Job Stamp 04-0120F4 SFOBB SAS

Report No.	_____			
Date	12/10/2007			
Inspectors	Start	09:40	Stop	11:50
Hours		13:20		14:00
Shift Hours	Start	07:00	Stop	15:30

Description of Operations @ W2 Cap Beam:

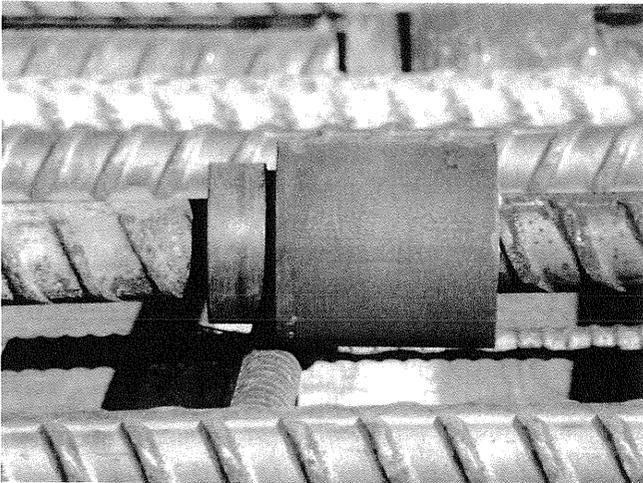
File Name: DSC00342		File Name: DSC00344	
Date: 12-10-07	By Int: SH Song	Date: 12-10-07	By Int: SH Song
Description: Coupler hand tightened and not straight as recommended per the Manufacturer Headed Reinforcement Corp.'s "Slip Test Handling For Inspectors & Testing Agencies". Pamela and myself informed Lance they need to be straightened before applying 400 ft-lb torque to mechanical coupler.		Description: Welding at cap beam "B" near stringer 13.

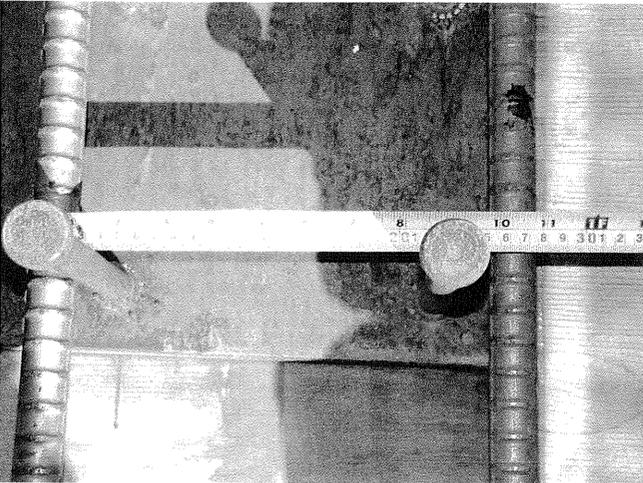
File Name: DSC00333		File Name: DSC00330	
Date: 12-10-07	By Int: SH Song	Date: 12-10-07	By Int: SH Song
Description: Need to provide clearance between Nelson Studs per Submittal 118. Refer to Conflict ID ME-2 in submittal.		Description: Reinforcement progress to date. RPS is close to address/correcting punchlist items for the B4 layer reinforcement (which is shown in the picture above) before proceeding with next layer of reinforcement.
